UNITED STATES PATENT AND TRADEMARK OFFICE

APPLICATION NO.	FILING DATE	FIRST NAMED INVENTOR	ATTORNEY DOCKET NO.	CONFIRMATION NO.
10/613,172	07/03/2003	Geoffrey D.M. Wilkie	LKMP:112US	9139
7590 11/30/2004				
Edward Tracy, Jr., Esq. Simpson & Simpson, PLLC 5555 Main Street Williamsville, NY 14221-5406			EXAMINER VASUDEVA, AJAY	
			ART UNIT 3617	PAPER NUMBER

Office Action Summary

DETAILED ACTION

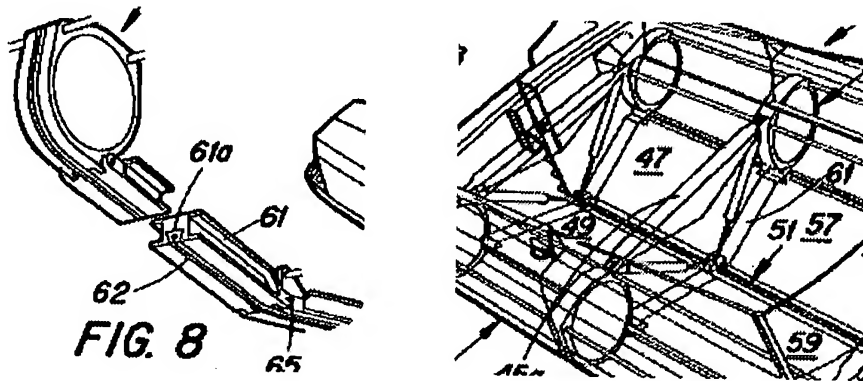
102(e) rejection based on Syfritt: The applicant has referred to figures 11a-11c, and argued that Syfritt does not show a truss assembly.

Examiners Answer: The Examiner has applied the embodiment shown in figures 7-10, and not figures 11a-11c. The arrangement of tie members 61 is considered equivalent to a truss assembly (see col. 9, lines 34-35; and the figures below).

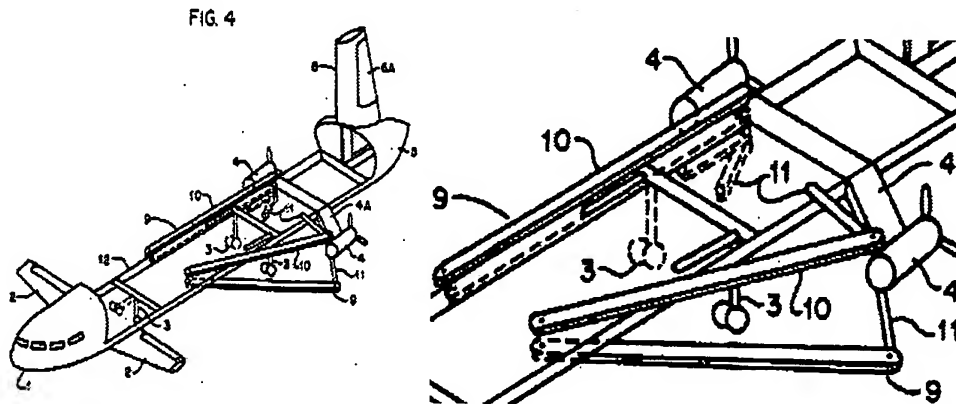
102(b) rejection based on Taylor: The applicant has argued that a truss is defined as "a frame...built from members in tension and compression", and that Taylor shows only pivoting and folding arrangement of spars, but these spars are not in tension or compression. Therefore, Taylor does not teach a truss assembly.

Examiners Answer: A truss is simply any framework, designed to provide support.

Further, the spars of Taylor are capable of withstanding both "tension and/or compression" stresses, even if they are not subjected to such forces. Applicant may further note the following excerpts from Taylor:
